**Town of Kittery  
Planning Board Meeting  
November 16, 2023**

**ITEM 3—283 US Route 1—Master Site Plan — Preliminary Review**

Action: Hold public hearing. Continue review. Neil Hansen, on behalf of owner/applicant Two International Group, is proposing a multi-phase project to re-develop existing commercial retail facilities into a 107-unit housing complex, 119 room hotel, and 6,000 square feet commercial building intended for a restaurant, along with associated parking and utilities, located on the property of 283 US Route 1, Map 30 Lot 44, in the Route 1 Commercial (C-1) Zone.

LANDSCAPE PLAN

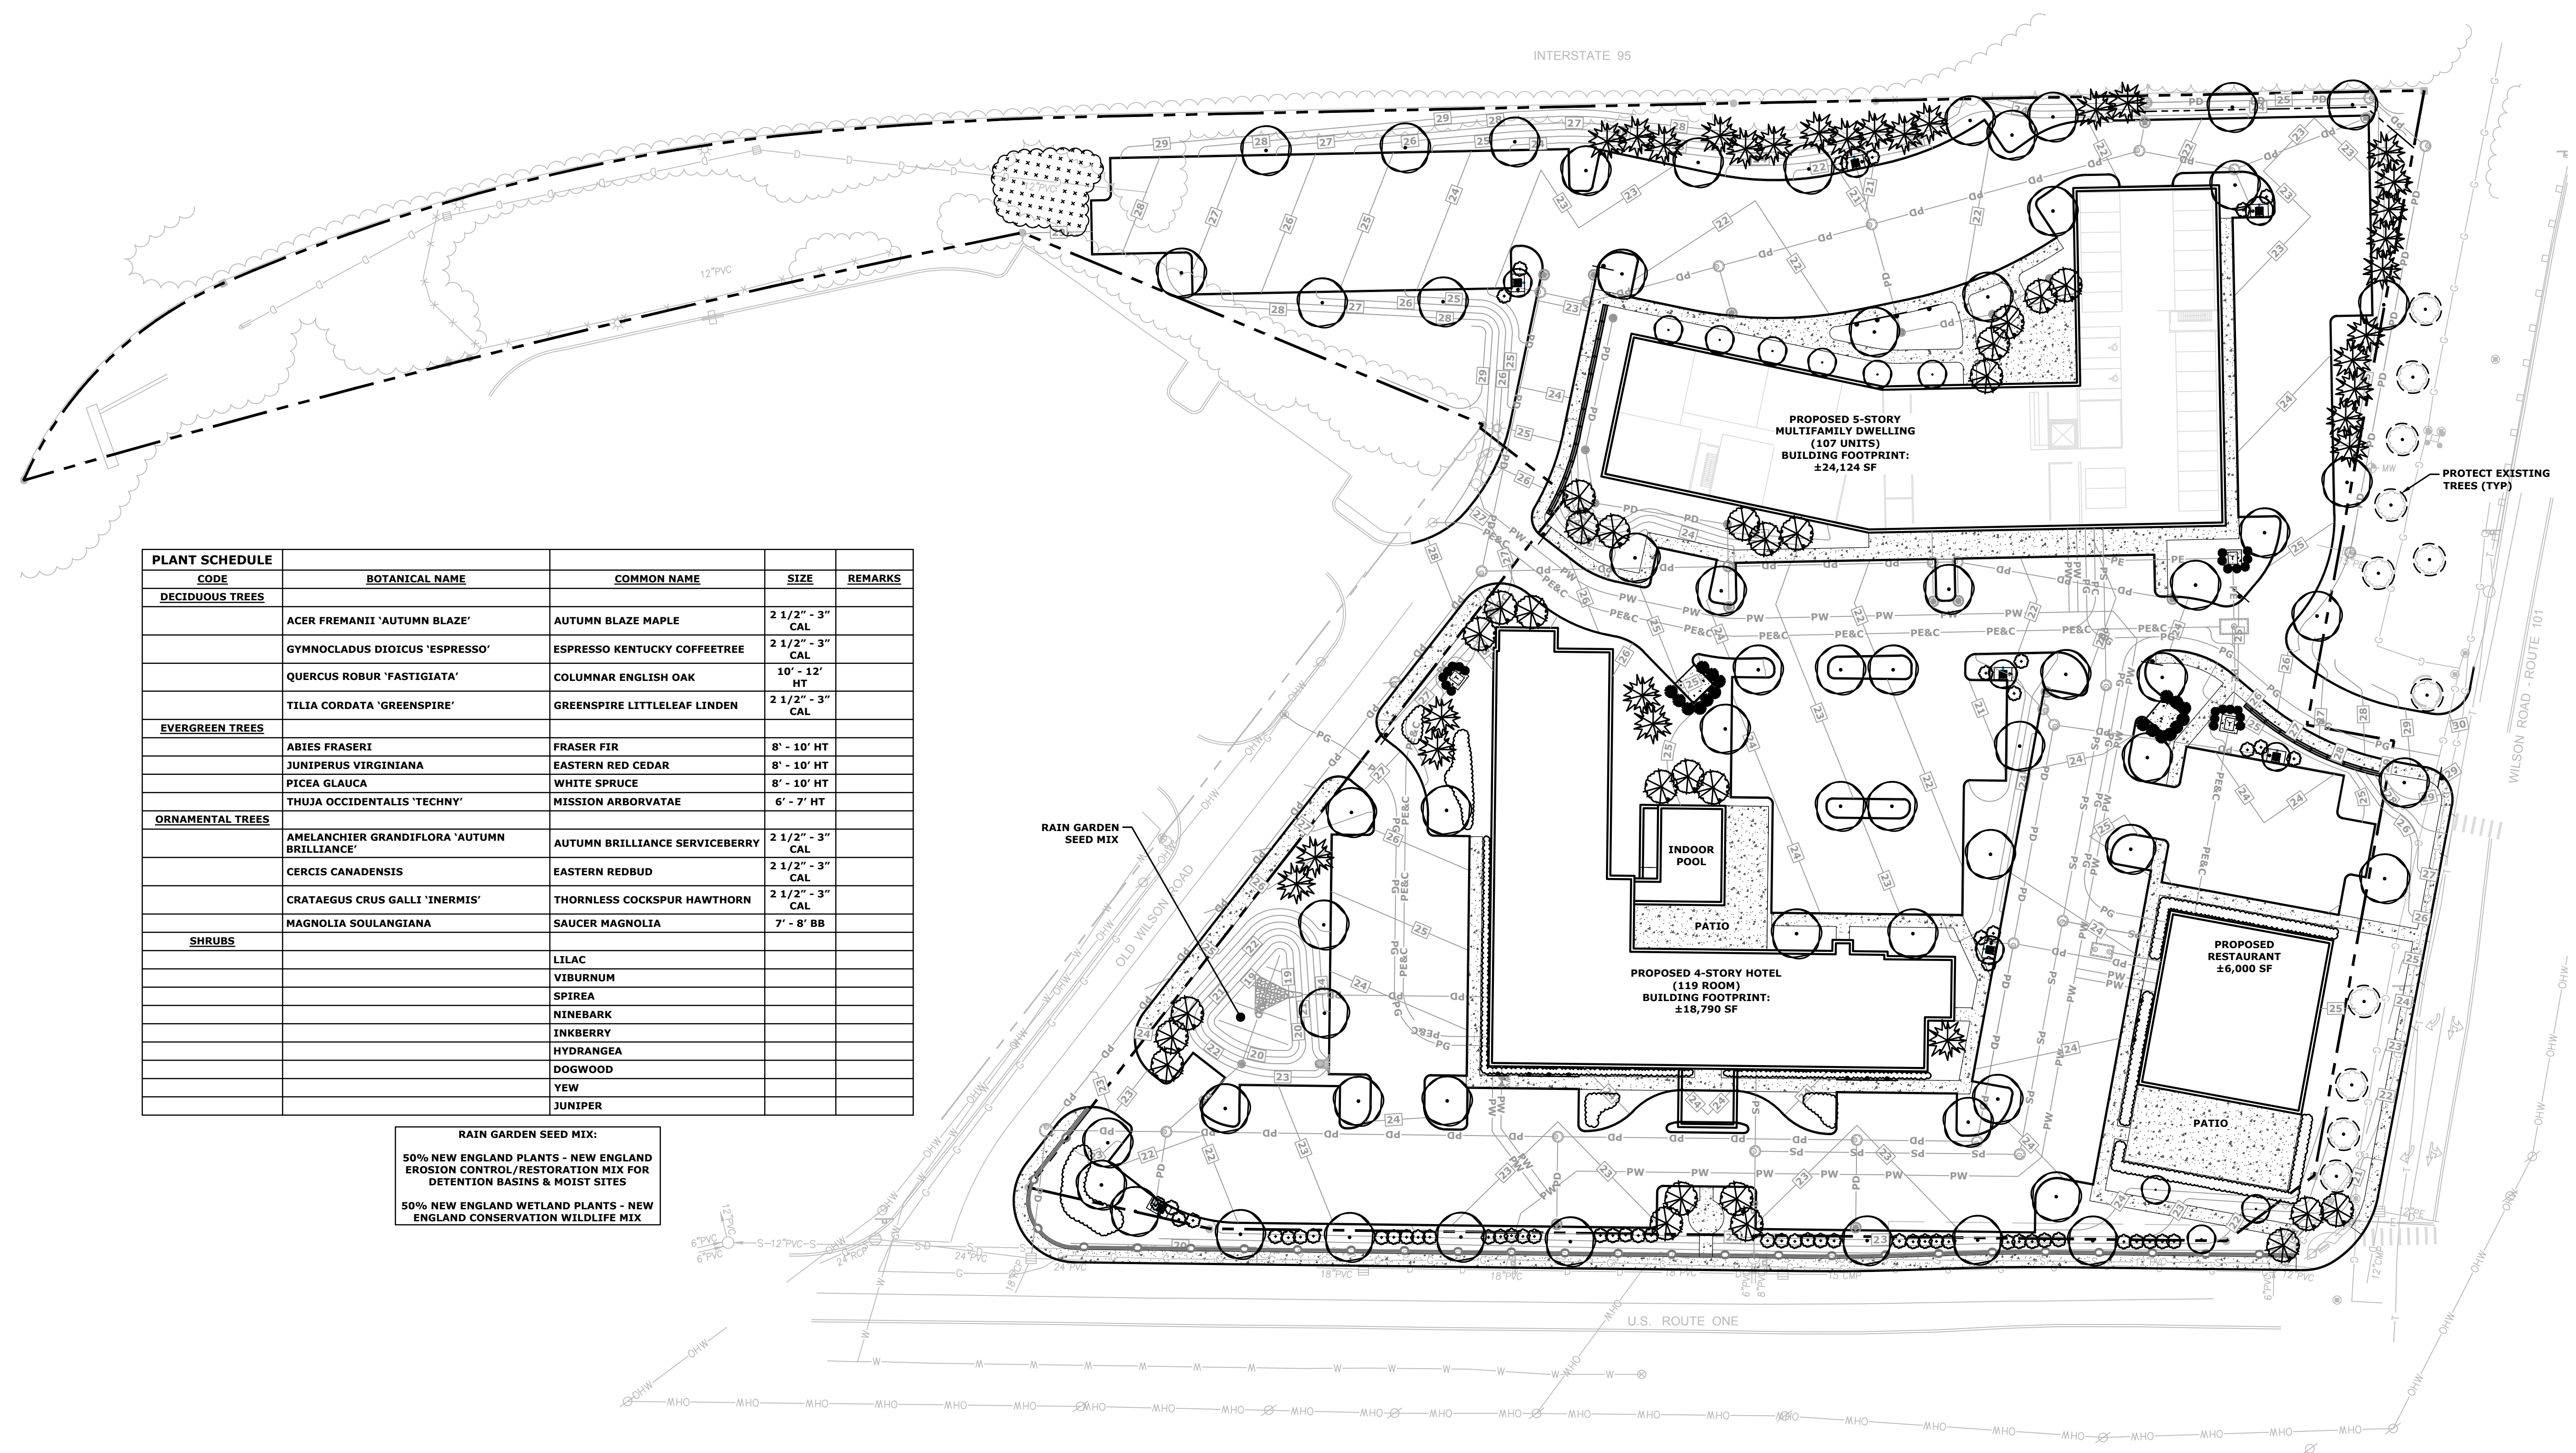
§16.4.19.E.(2).(m)..	Underground utilities are required	It appears the standard is satisfied
§16.4.19.E.(3).(a).	Parking standards: parking areas must be visually screened when abutting residential properties.	The proposal does not abut any residential properties. It appears the standard is satisfied.
§16.4.19.E.(3).(a).[2]	Parking space dimensions: minimum 19' x 9'	It appears the standard is satisfied.
§16.4.19.E.(4).(c).	<p>Parking must be on-site unless meeting requirements is determined impractical.</p> <p>20% of parking associated for multifamily dwellings may be designated for compact cars (if at least 10 spaces are required)</p>	All parking is located on-site. It appears the standard is satisfied.
§16.4.19.E.(3).(b).	The proposal must meet Kittery's building design standards.	The proposed developments appear to meet the design handbook guidelines.
§16.4.19.E.(3).(c)	<p>Landscaping improvements:</p> <ul style="list-style-type: none"> <li>• minimum 30 ft vegetated landscape planter strips between the lot and adjacent all rights-of-way.</li> <li>• One street tree for every 25 feet of street frontage</li> <li>• 10 plants per 40 linear feet of street frontage unless existing woodlands or being retained.</li> </ul> <p>NOTE: per §16.4.19.E.(4).(d), for surface parking lots that service a multi-family dwelling and abut a street, the following conditions also apply:</p> <ul style="list-style-type: none"> <li>• street trees must be backed by a fence.</li> <li>• 50% of trees and shrubs must be evergreen species</li> <li>• A minimum of 10% of parking area must be landscaped</li> </ul>	The applicant will show all standards are met in their landscaping plan before approval.
